**Re: Kimber Residence  
0 Pinecrest Parkway**

This letter is to request that the Steep Slopes and View Preservation Review be continued at the February 16, 2020 meeting of the Planning Board.

- A. An alternative design for the house consisting of three sheet of drawings prepared by Gotham Design & Community Development Ltd. under the review of Laura Wakefield, R.A., dated as submitted January 30, 2020, for the Planning Board.
- B. A Narrative documenting the fact that the subject property has steep slopes and making a request for a Special Hardship Exception from the Planning Board to permit the limits stipulated in the Code under Section 240-5.A. to be exceeded.

**SP-1**

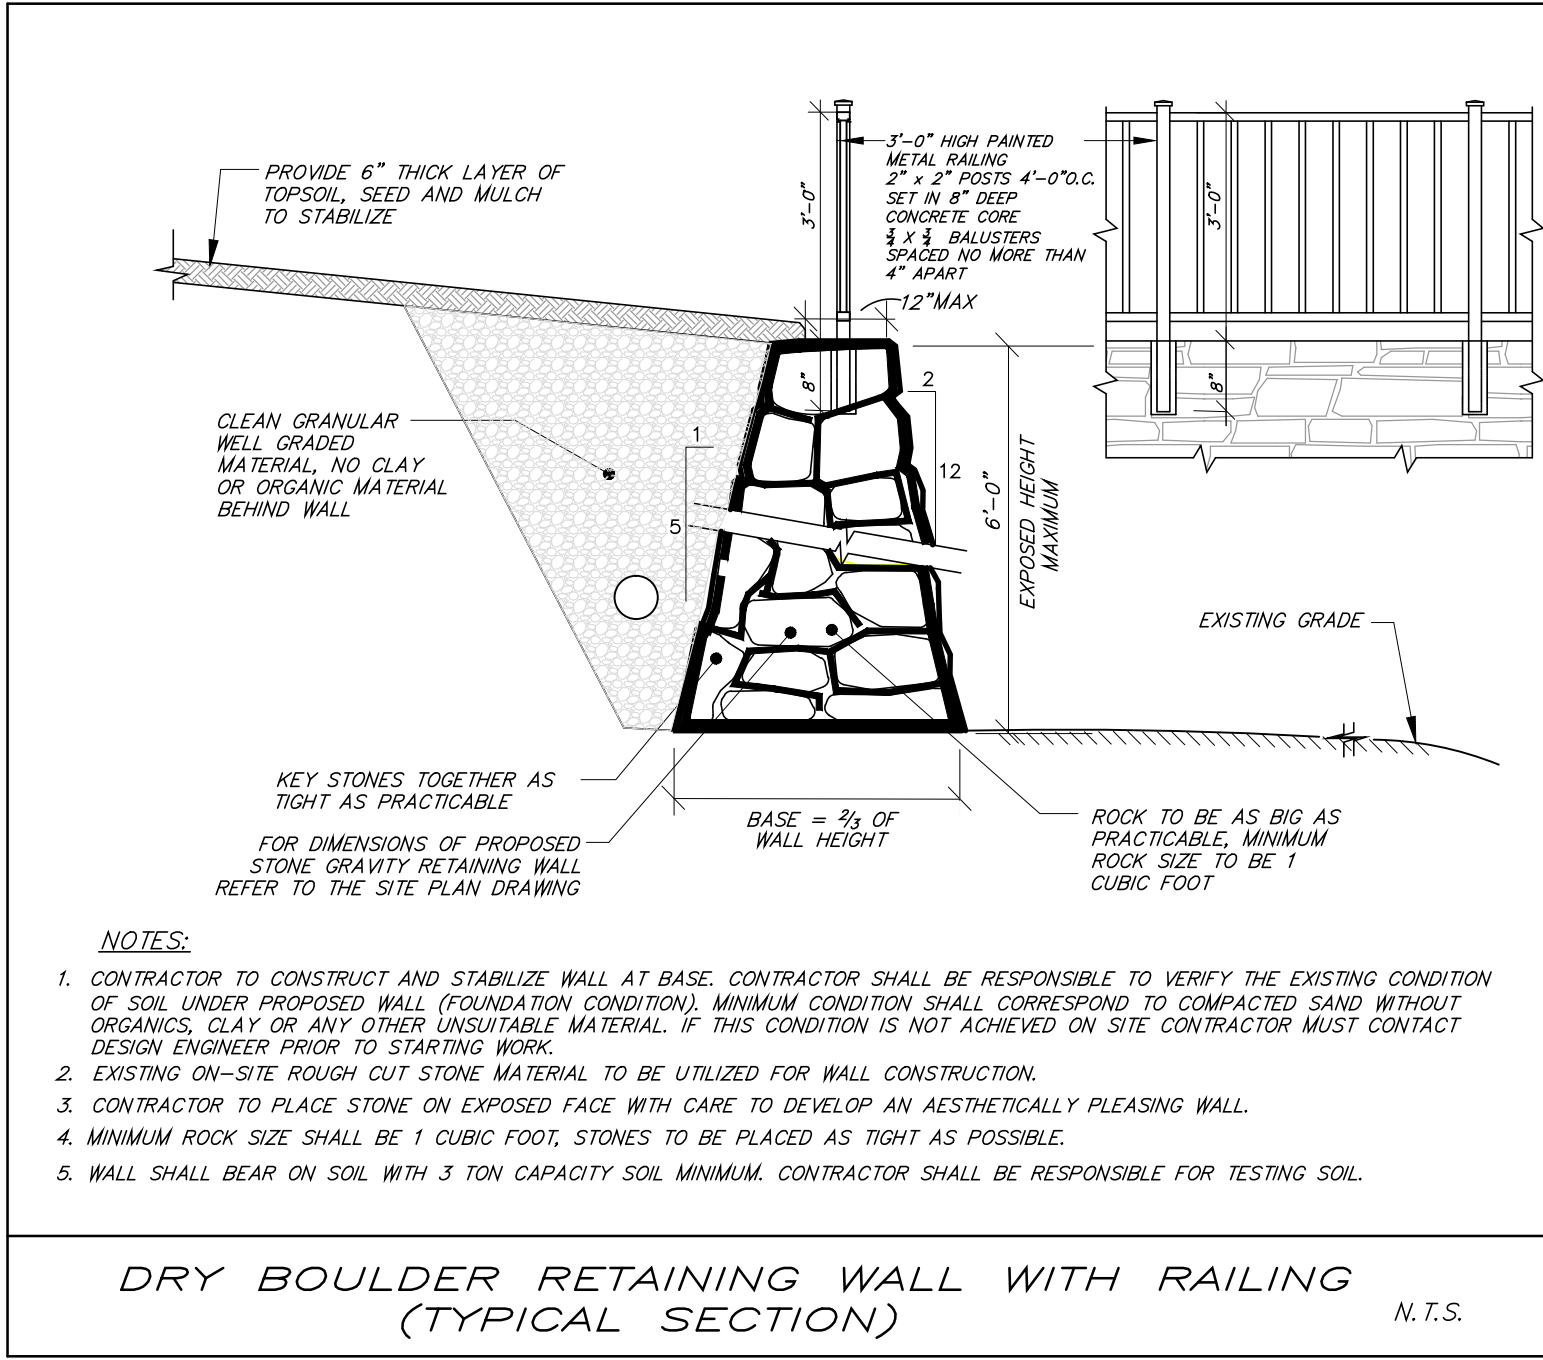
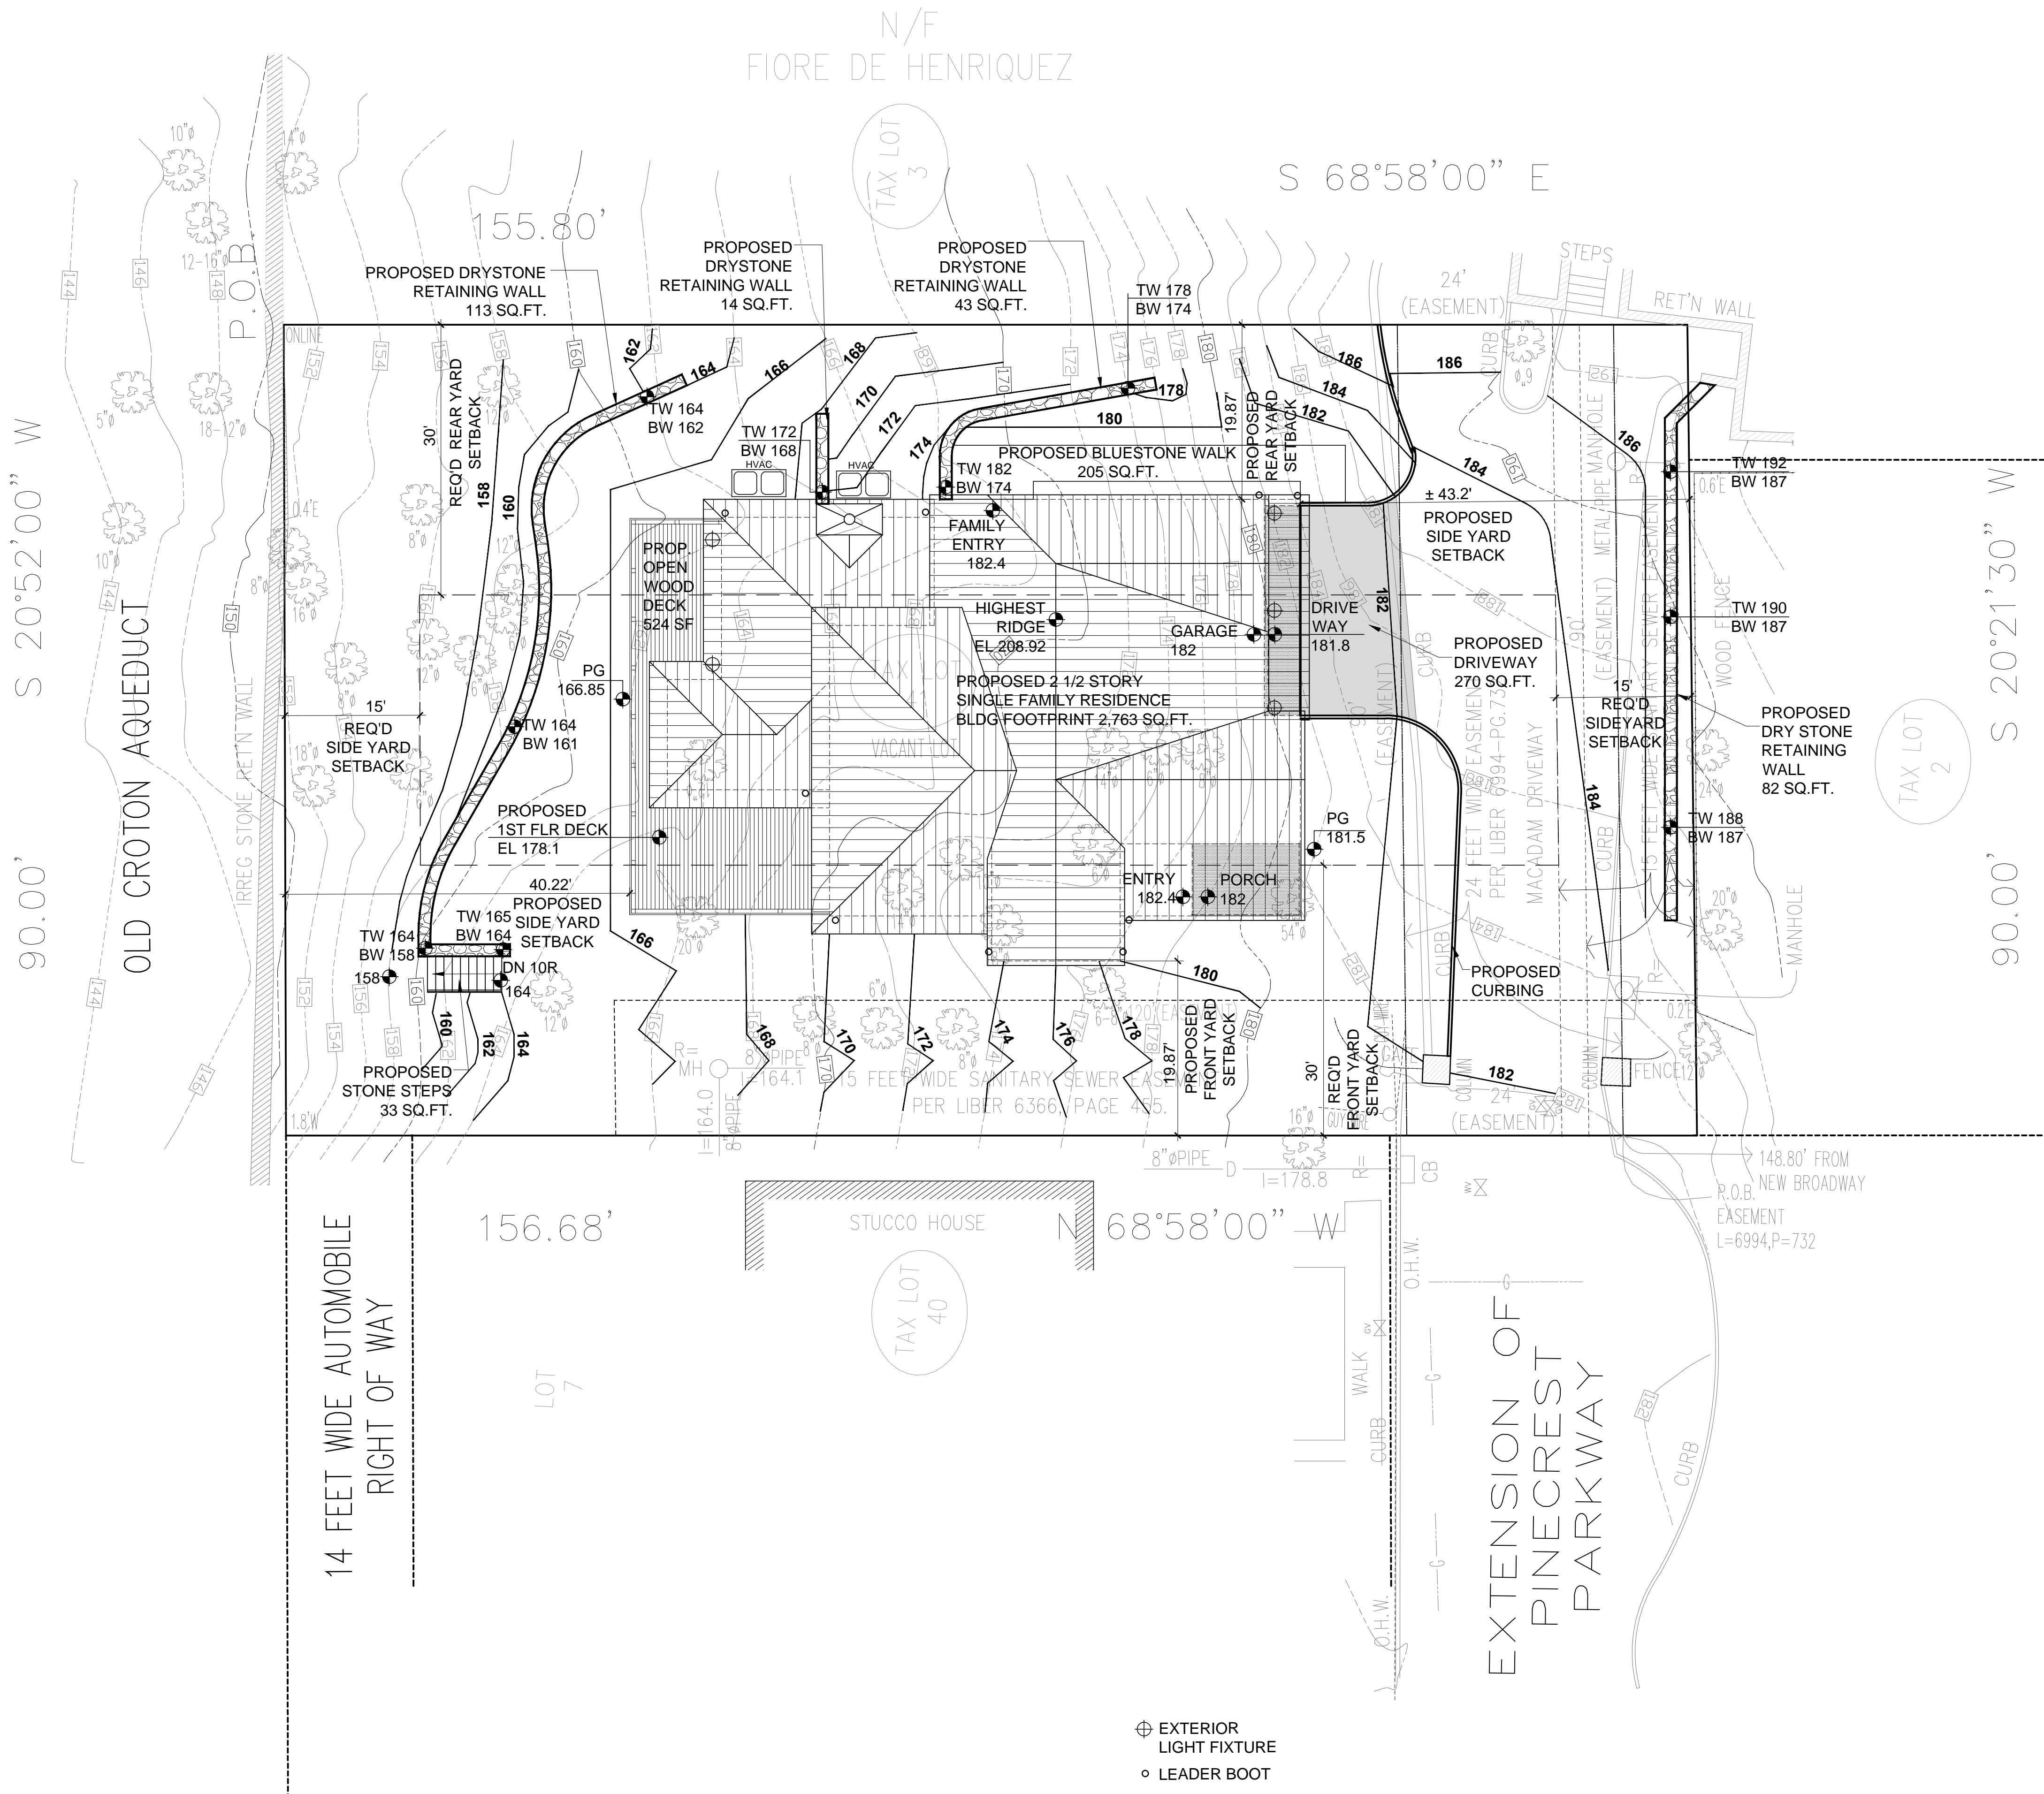
1. The courtyard in front of the house has been eliminated. This has moved approximately 610 square feet of the footprint of the house to the east.
2. The garage doors will now face the east instead of the south, which means that the vehicles will need to back out into the easement area. To avoid a condition in which cars parked in front of the garage would block the neighbors sharing the easement, we have shifted the garage 10 feet from the easement line.
3. By moving a portion of the house to the east, the width of the house has been reduced from the original design of 59 feet overall running north/south to 50 feet overall running north/south. This has allowed the front yard and rear yard setbacks to be increased from 15 feet to 19.87 feet each.

4. It should be noted that only a small section of the south side of the alternative design house is set back the 19.87 feet from the property line. The bulk of the house is now set back 24.87 feet from the south property line.
